Client: New Home Inc  
Project:  
Address: 1723 Neills Creek Road, Lillington NC

Date: 3/19/2025  
Input by: Johnnie Baggett  
Job Name: The Selma  
Project #: J1023-5899/5900

**FJ1 NI-40x 11.875" - No Repair Required**  
**See User Note 1**

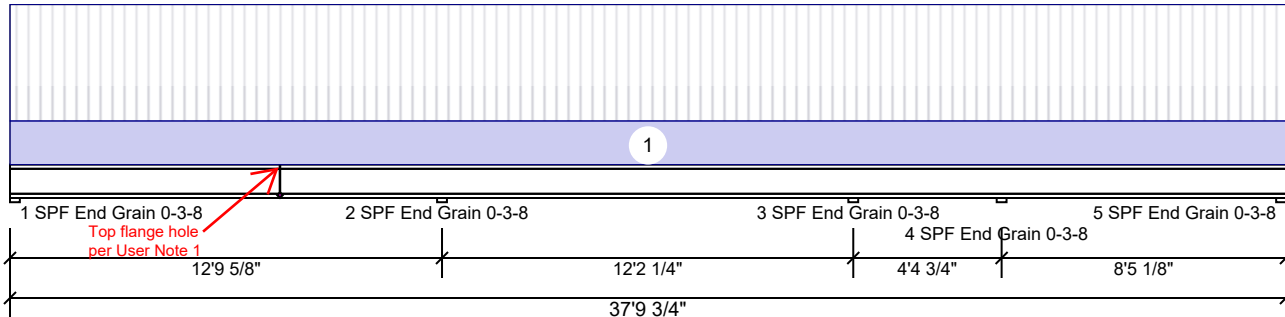
- 1 Location analysis indicates center of 1/2" diameter vertical hole in one leg of top flange. The web was not disturbed. No repair required.

**FJ2 NI-40x 11.875" - No Repair Required  
See User Note 1**

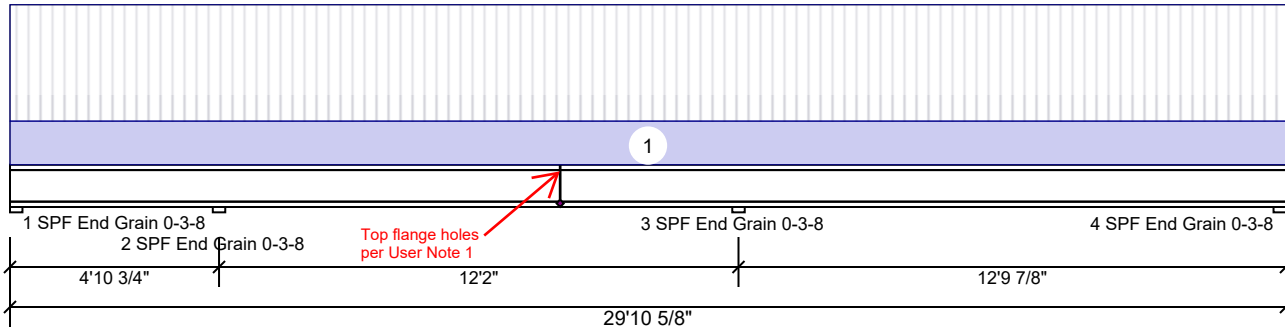
- 1 Location analysis indicates mid-point between two, 1/2" diameter vertical holes in one leg of top flange. The web was not disturbed. No repair required.

**FJ3 NI-40x 11.875" - No Repair Required**  
**See User Note 1**

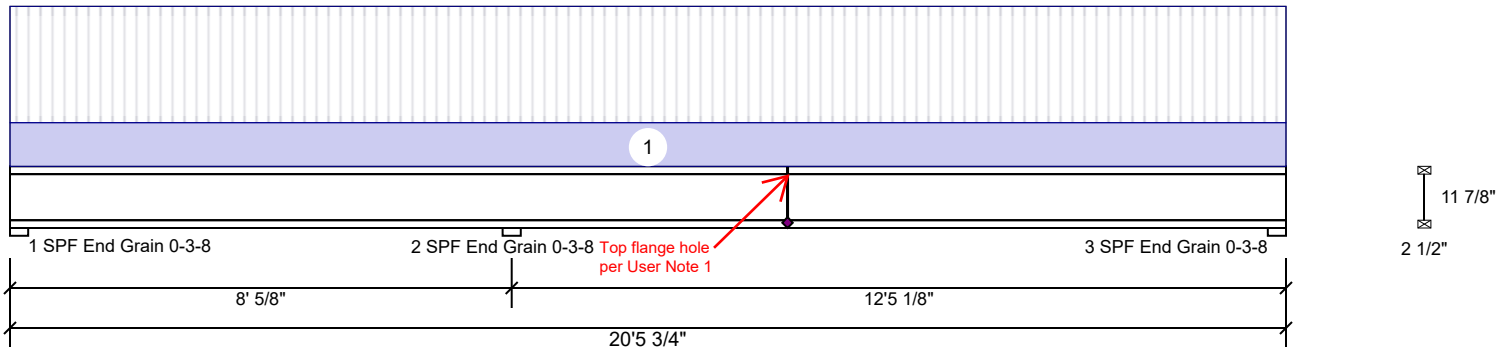
- 1 Location analysis indicates center of 1/2" diameter vertical hole in face of one leg of top flange. No repair required.

**FJ4 NI-40x 11.875" - No Repair Required  
See User Note 1**

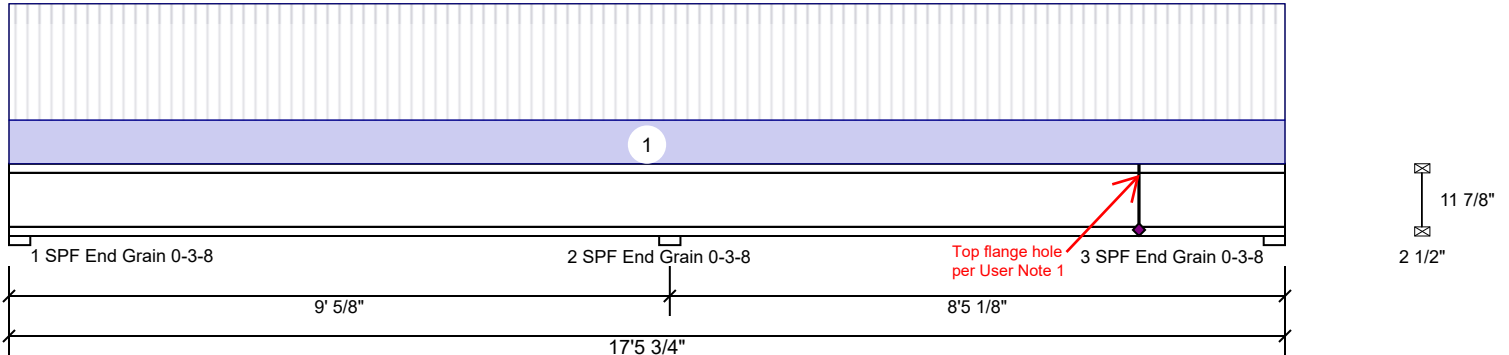
- 1 Location analysis indicates center of 1/2" diameter vertical hole in face of one leg of top flange. No repair required.

**FJ6 NI-40x 11.875" - No Repair Required**  
**See User Note 1**

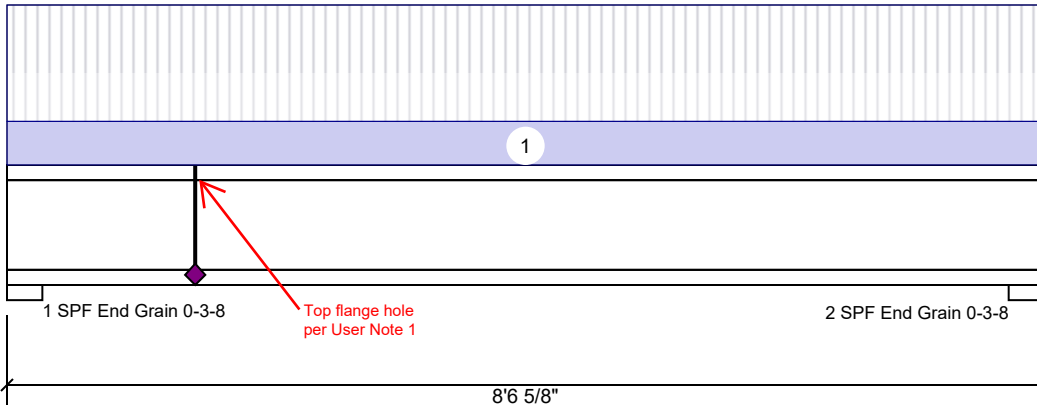
- 1 Location analysis indicates center of 1/2" diameter vertical hole in face of one leg of top flange. No repair required.
